Project	IEEE 802.16 Broadband Wireless Access Working Group < http://ieee802.org/16 >
Title	Amendment to Idle Mode Service Primitives
Date Submitted	2007-03-1409
Source(s)	Jeehyeon Na, Jaesun Cha, JungMo Moon and Sangho Lee jhna@etri.re.kr ETRI 161 Gajeong-dong, Yuseong-gu Daejeon 305-700 Korea
Re:	Contribution on comments to IEEE 802.16g/D8
Abstract	Re-definition of Idle mode service primitives in section 14.2.4.2
Purpose	Adoption
Notice	This document has been prepared to assist IEEE 802.16. It is offered as a basis for discussion and is not binding on the contributing individual(s) or organization(s). The material in this document is subject to change in form and content after further study. The contributor(s) reserve(s) the right to add, amend or withdraw material contained herein.
Release	The contributor grants a free, irrevocable license to the IEEE to incorporate text contained in this contribution, and any modifications thereof, in the creation of an IEEE Standards publication; to copyright in the IEEE's name any IEEE Standards publication even though it may include portions of this contribution; and at the IEEE's sole discretion to permit others to reproduce in whole or in

Figure 479—Subscriber mode transition diagram at NCMS ([on BS or MS side](#))

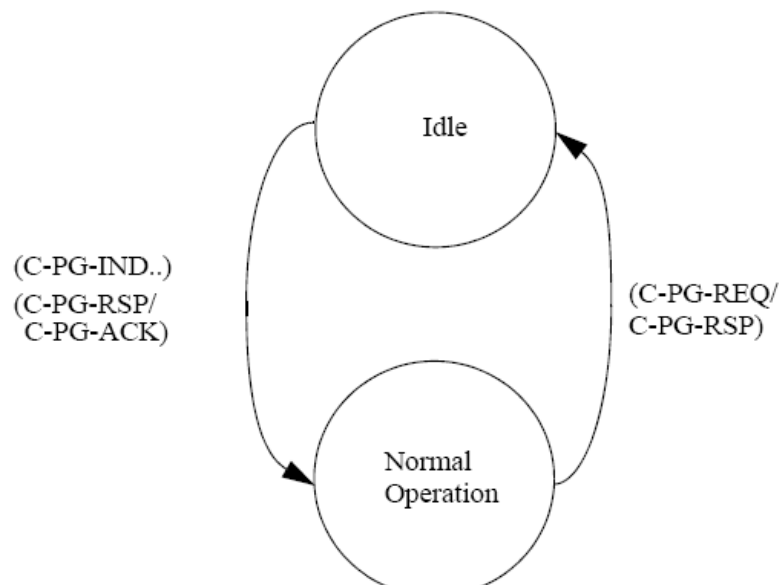
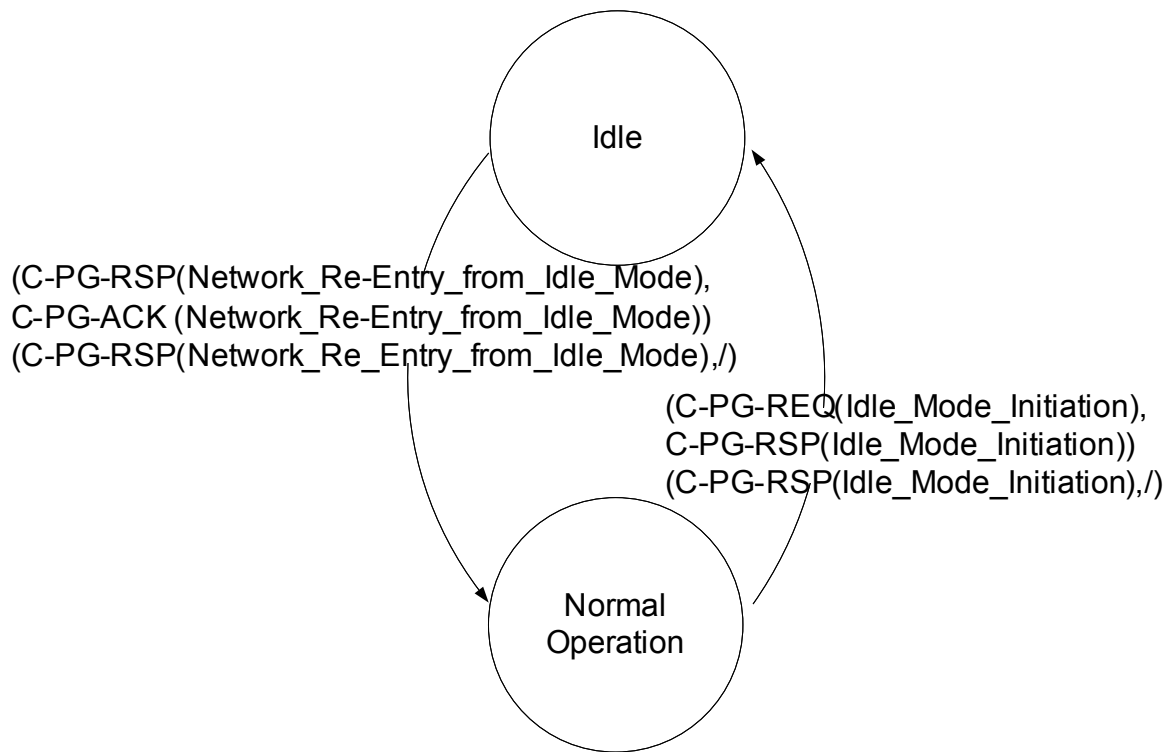
Subscriber mode management is described as informative in section 14.2.4 and it is managed at an MS, a BS and an NCMS. Figure 479 which shows subscriber mode transition diagram at an NCMS is not clear whether for an NCMS on a BS and an MS side or not.

Therefore, we clarify figure 479 and the related texts in order to be used both NCMS at an MS and a BS side.

Figure 479 shows Subscriber Mode transition diagram at the NCMS with service primitives related with the Subscriber Mode transition. Subscriber Mode transition from Normal Operation to Idle Mode is performed by exchanging C-PG-REQ and C-PG-RSP between ~~a BS~~ an 802.16 entity and the NCMS after successful DREG-REQ message from the MS with De-Registration Request Code=0x01 or DREG-CMD message from the BS with Action Code = 0x05, where C-PG-REQ and C-PG-RSP are defined in 14.2.4.2.1 and 14.2.4.2.2, respectively. Subscriber Mode transition from Idle Mode to Normal Operation is initiated after exchanging ~~C-PG-IND, C-PG-RSP,~~ and C-PG-ACK between an 802.16 entity ~~BS~~ and the NCMS, where ~~C-PG-IND, C-PG-RSP,~~ and C-PG-ACK are defined in ~~14.2.4.2.4,~~ 14.2.4.2.2, and 14.2.4.2.3, respectively.

Figure 480 – Idle mode initiation (NCMS on the MS side)

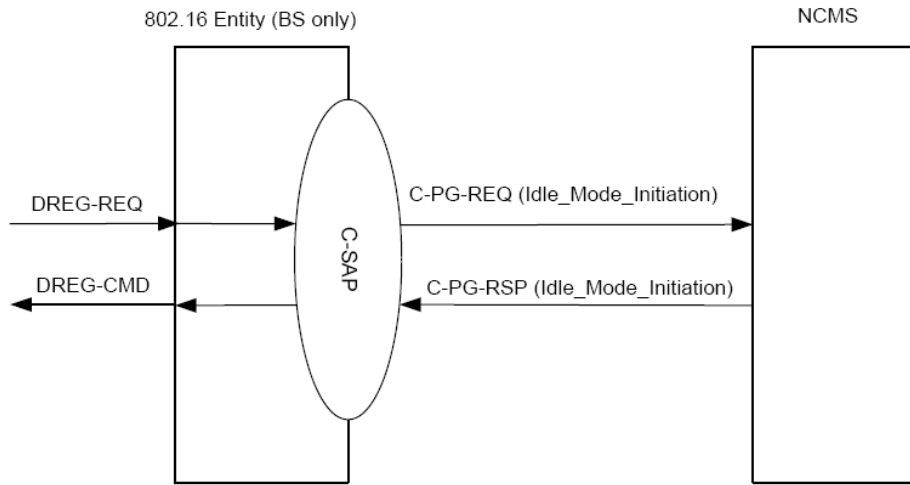
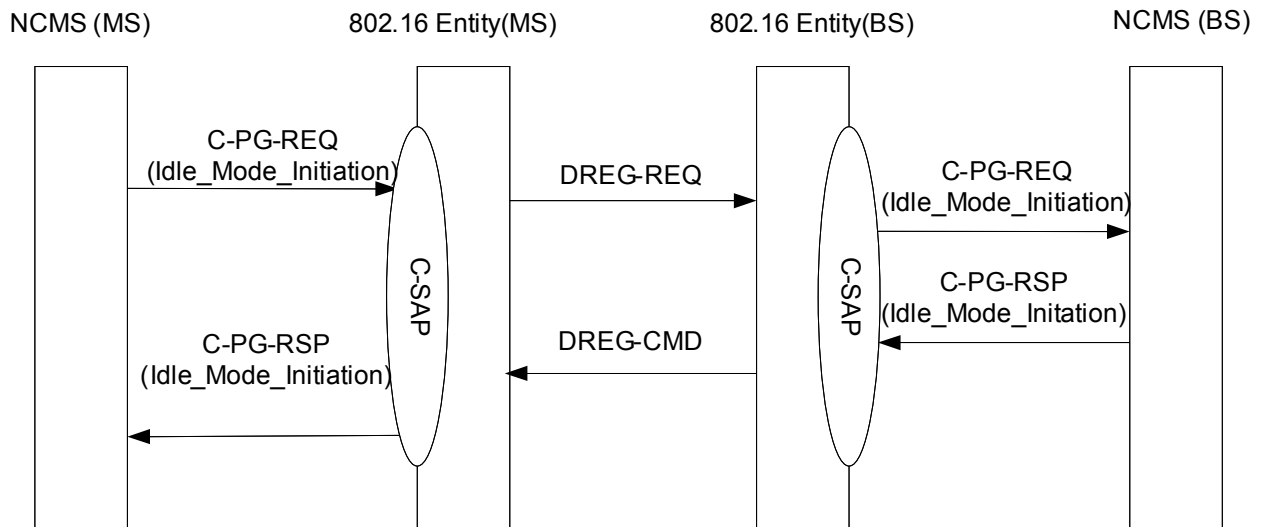
Therefore, we propose to change figure 480, 482, 483 to the figures which are included the service primitives between an 802.16 entity (MS) and an NCMS on the MS side and modify the related service primitives parameters in this contribution. And we also correct some editorial texts.

[Change the figure 480 and its title to as follows]

Figure 482- Paging Announce

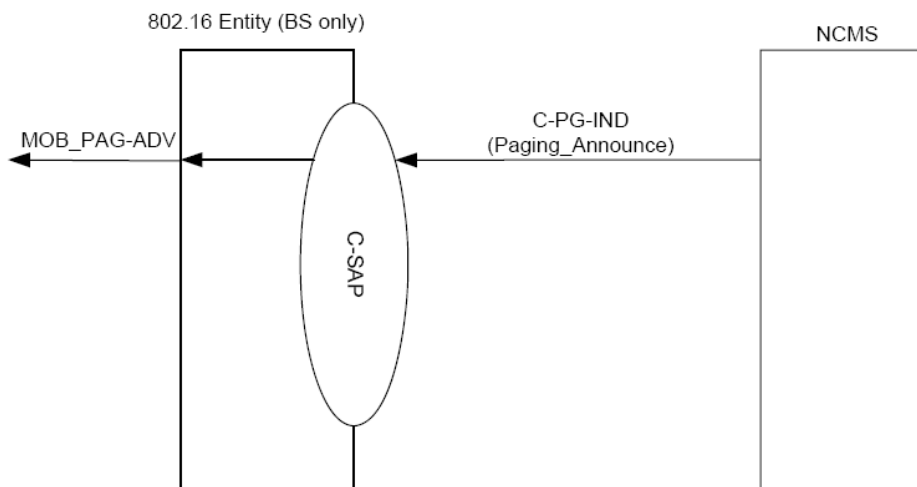
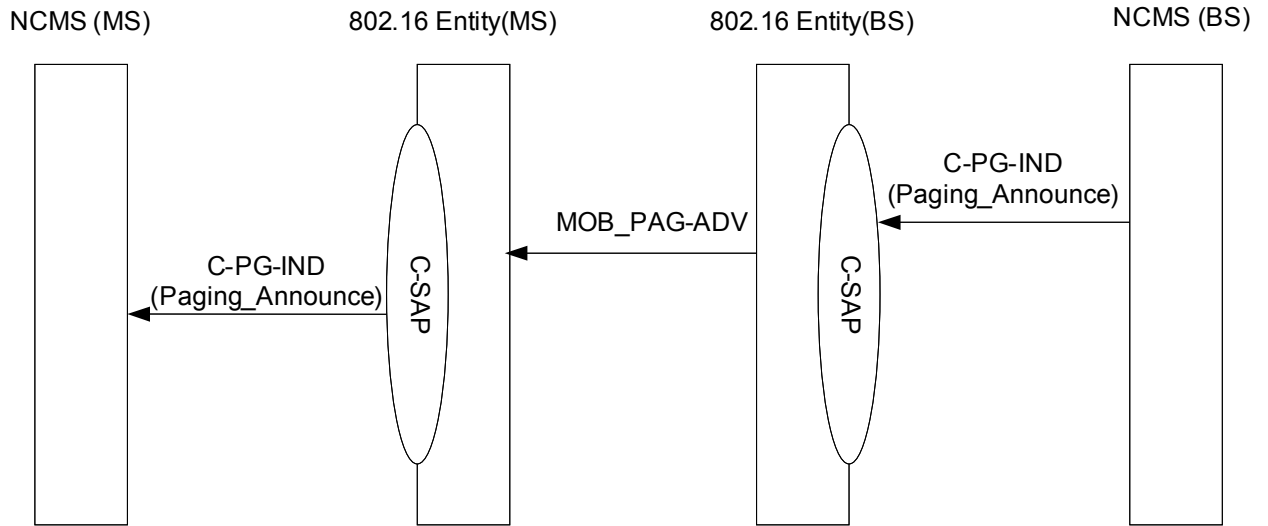
[Change the figure 482 to the following figure Section 14.2.4.2]

Figure 483- Network re-entry from Idle mode primitives

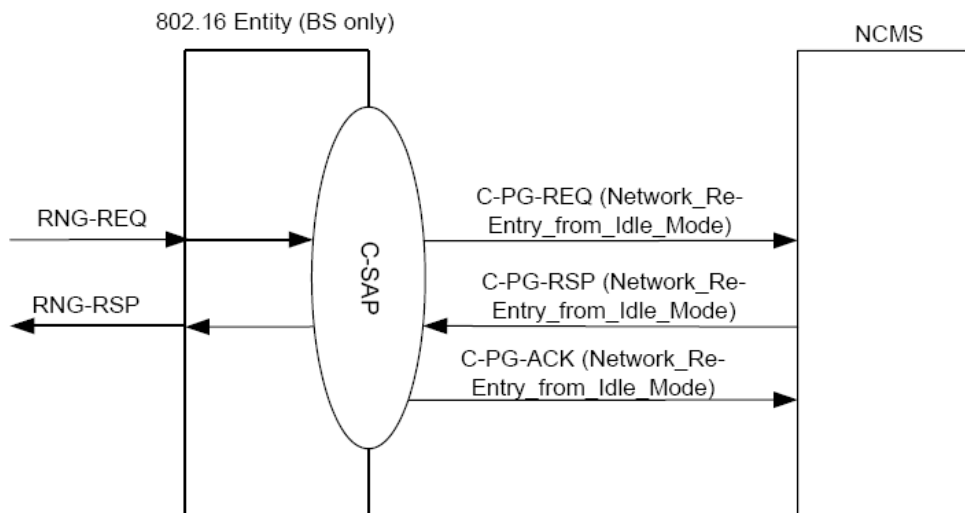
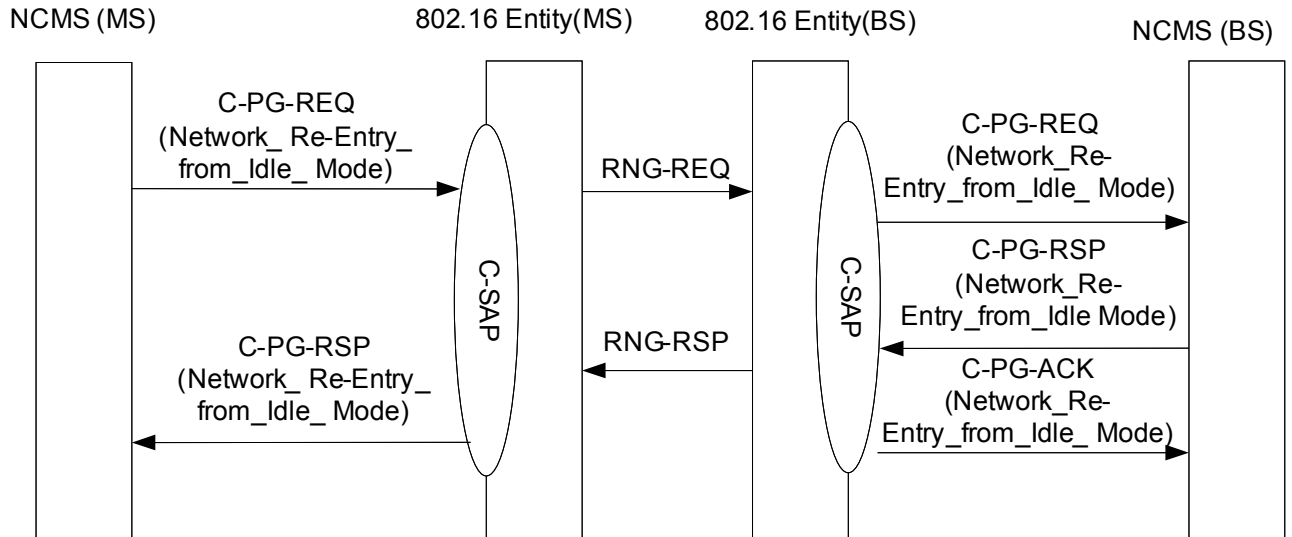
[Change the figure 483 to the following figure in 14.2.4.2]
